ADDENDUM NUMBER 01

RENOVATION OF SHERIDAN PARK PAVILION
4800 South Lake Drive
Cudahy, Wisconsin 53110

Date of Addendum: 6/16/2014

11 SILL @ ENTRY SIDELITE (DOOR SILL SIMILAR)
SCALE: 3" = 1'-0"

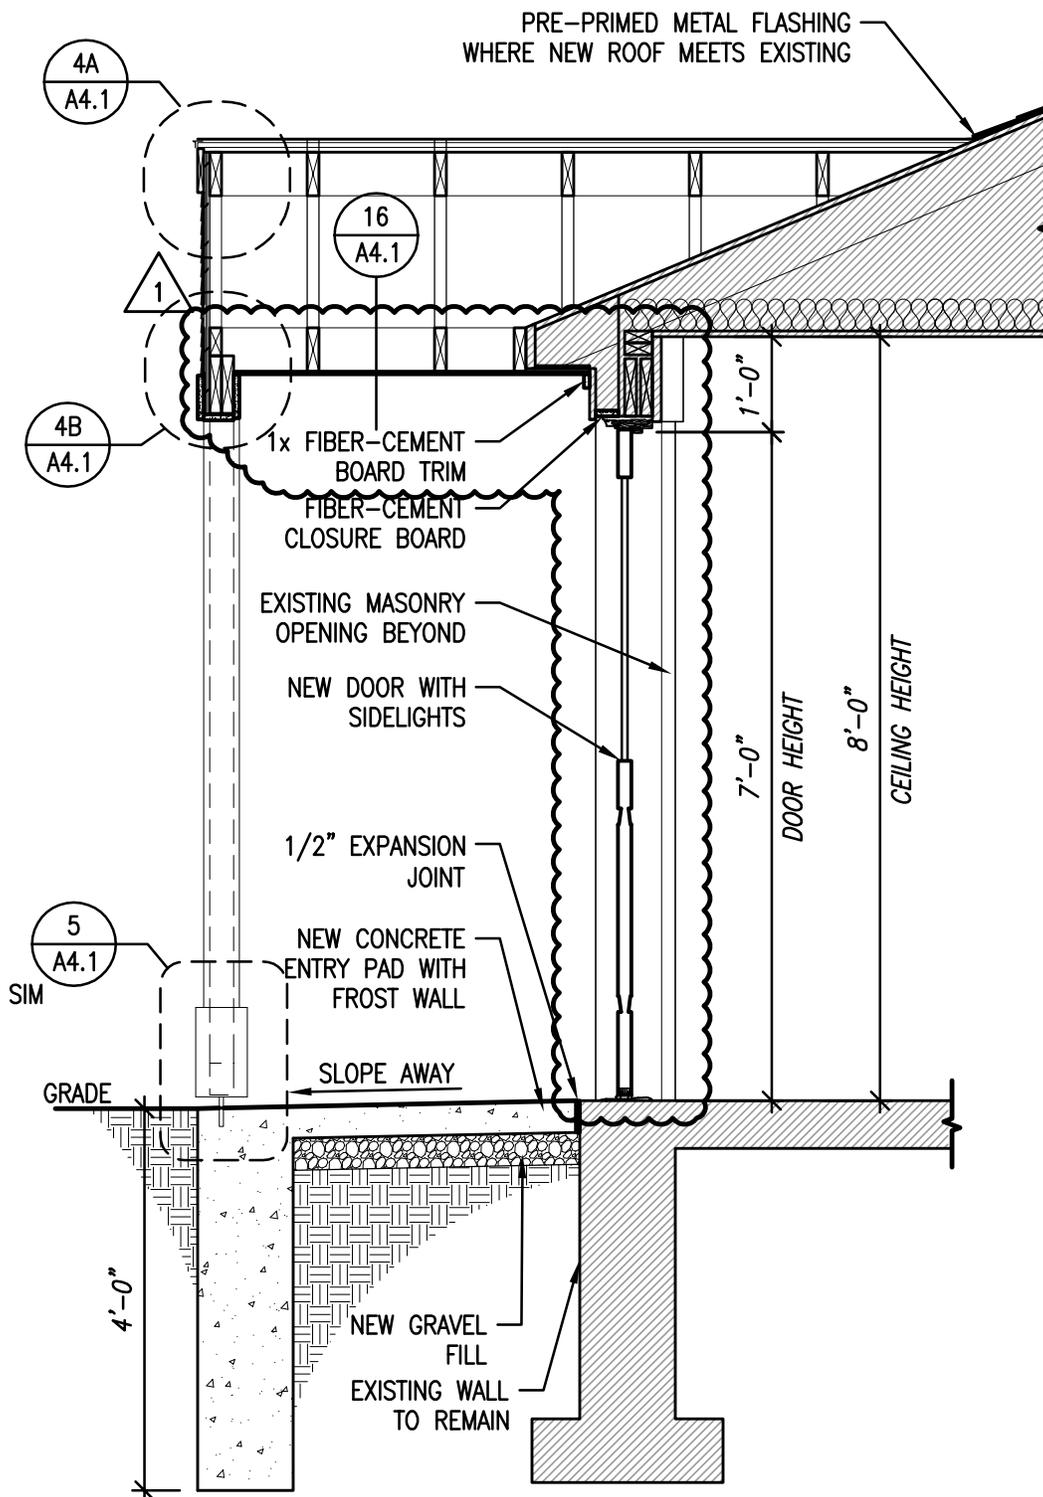
1. **Add** window details. See attached drawings A4.1-1, A4.1-2, A4.1-3, A4.1-4, A4.1-5, A4.2-1, A4.2-2, A4.2-3, A4.2-4, A4.2-5, A4.2-6, A4.2-7, A4.2-8, A4.2-9, A4.2-10
2. **Add** entry door details. See attached drawings A4.1-6, A4.1-7, A4.1-8, A4.1-9
3. **Revise** Detail 4A/A4.1 and 16/A4.1 to show the continuous drip edge to lap fascia board by least 1".
4. **Revise** all references to Prefinished Cement Board siding to be Pre-Primed Cement Board Siding.
5. **Revise** details 2/A4.1 and 3/A4.1 to alter the soffit and new door conditions. See attached drawings A4.1-9 and A4.1-10.

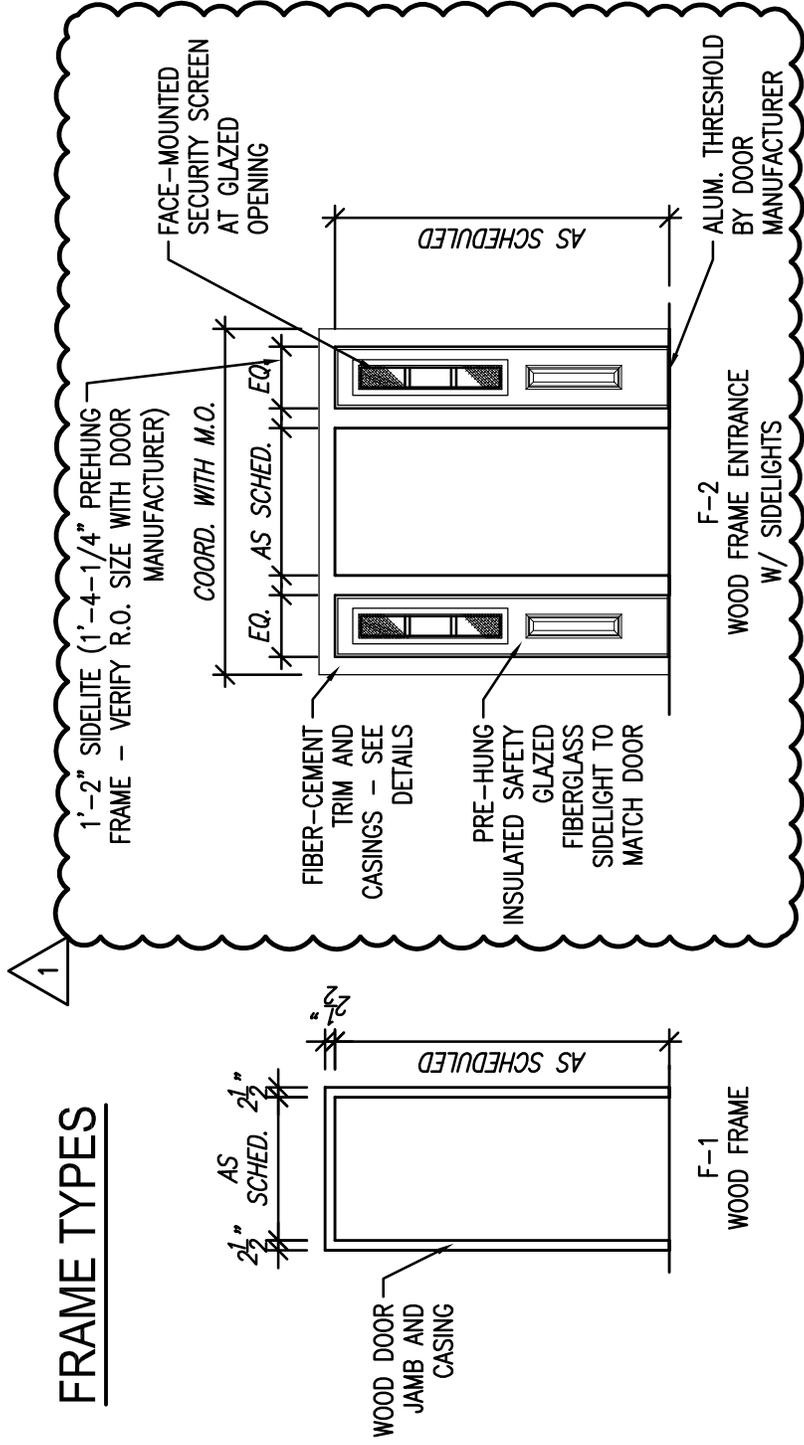
1. **Revise** CB-2 to be Cement Lap Board Siding. See attached drawing A5.1-1.
2. **Revise** hardware schedule. See attached drawing A5.1-1.
3. **Revise** Door D1 and Frame F-2. See attached drawing A5.1-2

CB-2 CEMENT BOARD LAP SIDING
 MANUFACTURER: JAMES HARDIE OR EQUAL
 EXPOSURE: 4"
 COLOR: PRIMED FOR PAINTING
 STYLE: SELECT CEDARMILL COLOR PLUS

H1

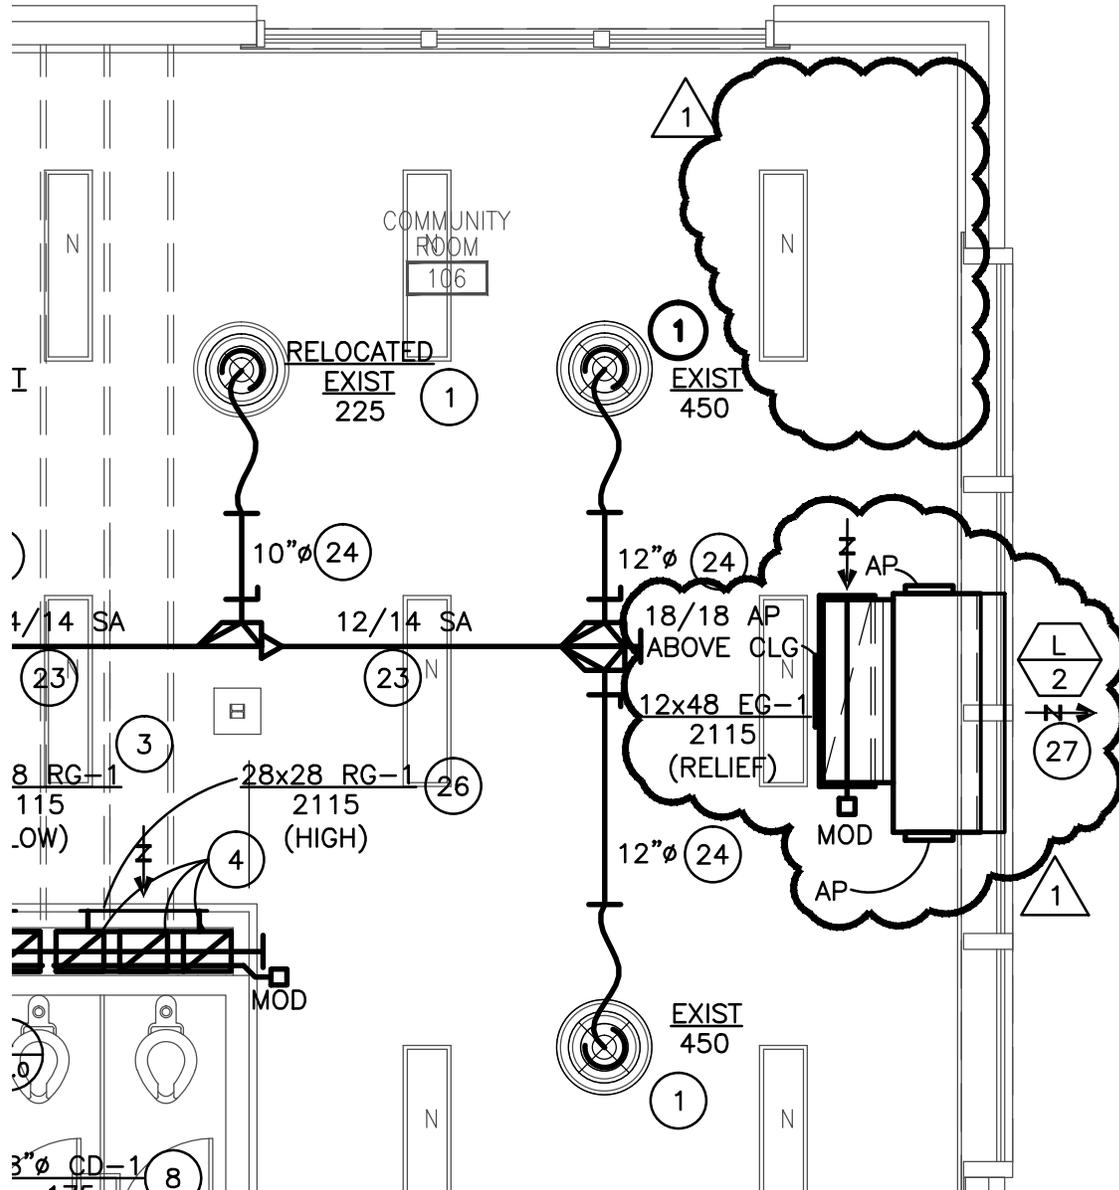
1. **Delete** Outside Air and Relief Air Roof Hoods. See attached drawings H1 and H2.
2. **Revise** Keyed Notes #17 and #27 to provide Outside Air and Relief Air Louvers. See attached drawings H1, H2, and H3.
3. **Delete** 10x5 louver for Combustion Air. See attached drawing H2.
4. **Revise** Keyed Note #22 to provide 16"x16" Louver. See attached drawings H1 and H2.
5. **Delete** 5" diameter Combustion Air Intake through roof, see revised Keyed Note #19 drawing H2.
6. **Add** louver schedule with L-1, L-2 & L-3. See drawing H3.

- 17. LOUVER L-1 FOR OUTSIDE AIR INTAKE, WITH BIRDSCREEN. PROVIDE 60"x24"x18" INSULATED PLENUM WITH (2) 12"x12" ACCESS PANELS. INSTALL LOUVER L-1 PER MANUFACTURERS RECOMMENDATIONS.
- 18. NEW EXHAUST FAN IN ATTIC, SUPPORT FROM STRUCTURE PER SPECIFICATIONS AND MANUFACTURER'S RECOMMENDATIONS.
- 19. EXTEND 5" DIA. COMBUSTION AIR INTAKE INTO ROOM.
- 22. 16"x16" HEAVY-DUTY WALL LOUVER FOR COMBUSTION AIR INTAKE. PROVIDE SCREEN IN REMOVABLE FRAME.
